Engineering Change Notice(ECN)

ECN-D-2601-06(Vacuum Pad Holder Engraving)

3-1. VACUUM PAD HOLDER ASSY No. Change

3-2. VACUUM PAD ASSY BOM

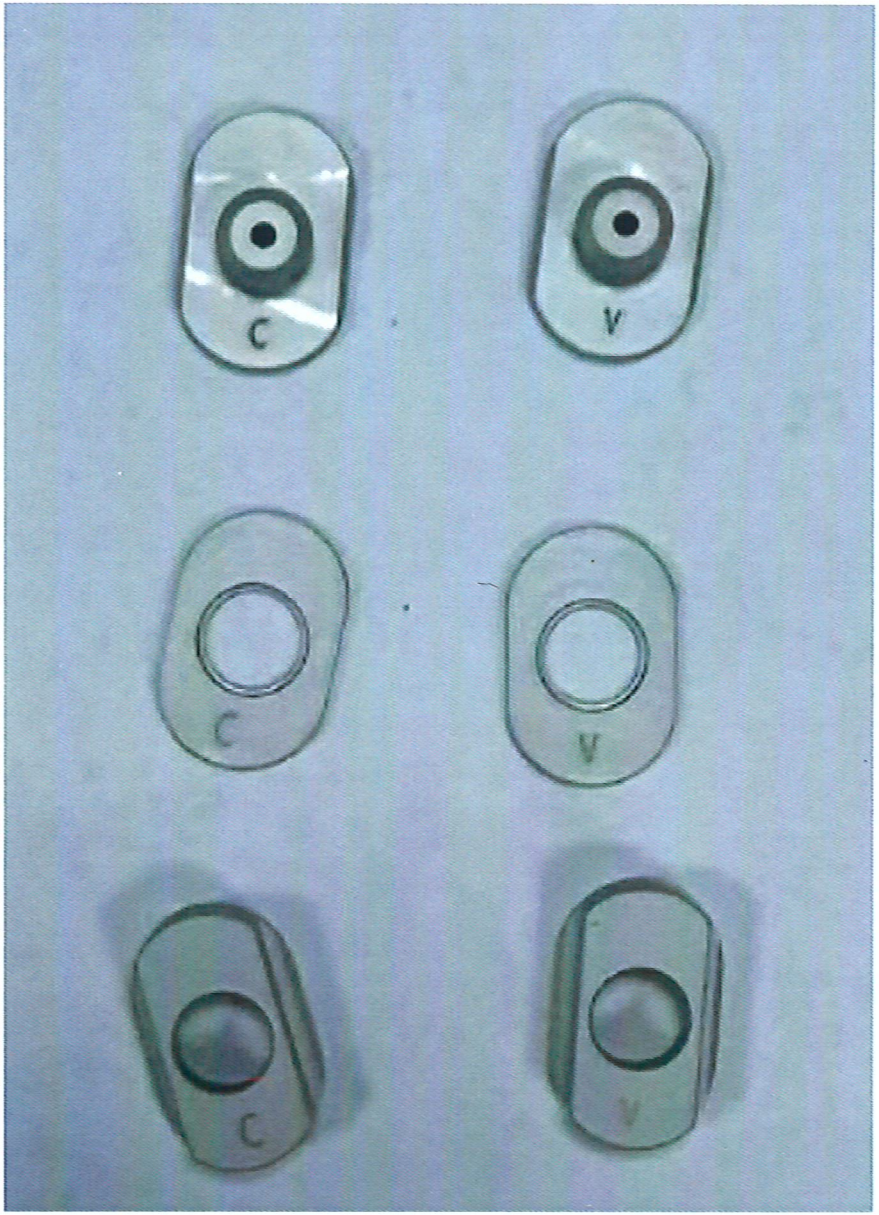
All related equipment and hand M-BOMs shall be updated accordingly.
